Agenda Item # 1 - HOLDOVER

SUB-003642-2026

Willis-Sermon Connector Subdivision

WILLIS-SERMON CONNECTOR SUBDIVISION

DETAIL SITE PLAN

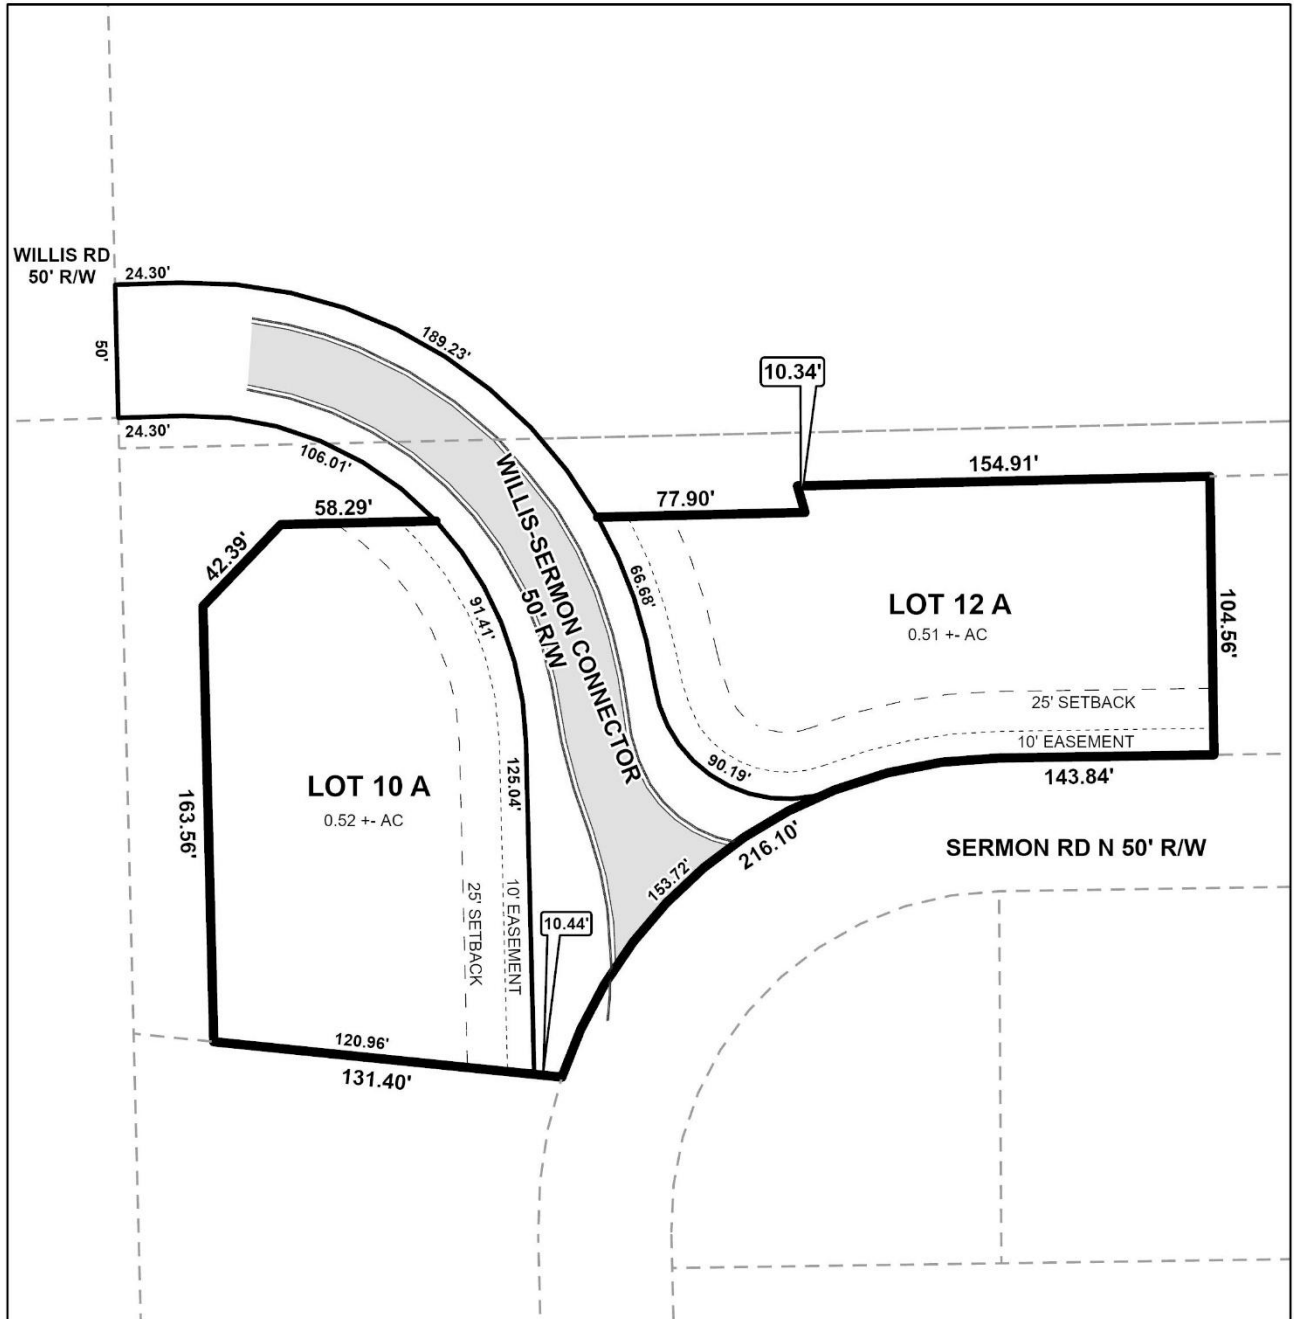
- B. The existing COMMON AREA (DETENTION) – Parcel 023308273000025.000 – is being split into two 92) separate parcels with the dedication of the proposed ROW. Also, a portion of Parcel 023308273000020.001 is proposed to be added to the western side of the existing COMMON AREA (DETENTION). The new parcels will need to be labeled with a unique designation (i.e. COMMON AREA (DETENTION) #1 and COMMON AREA (DETENTION) #2)

- C. Show the “old” lot line of the COMMON AREA (DETENTION) that bisects the proposed ROW.
- D. SURVEYOR’S NOTES #7 – include the amount of ROW dedication (acres and SF).

- E. SITE DATA TABLE – provide the exact length of the proposed street centerline.
- F. Review and revise the written legal description to include a written bearing and distance near Lot 6.
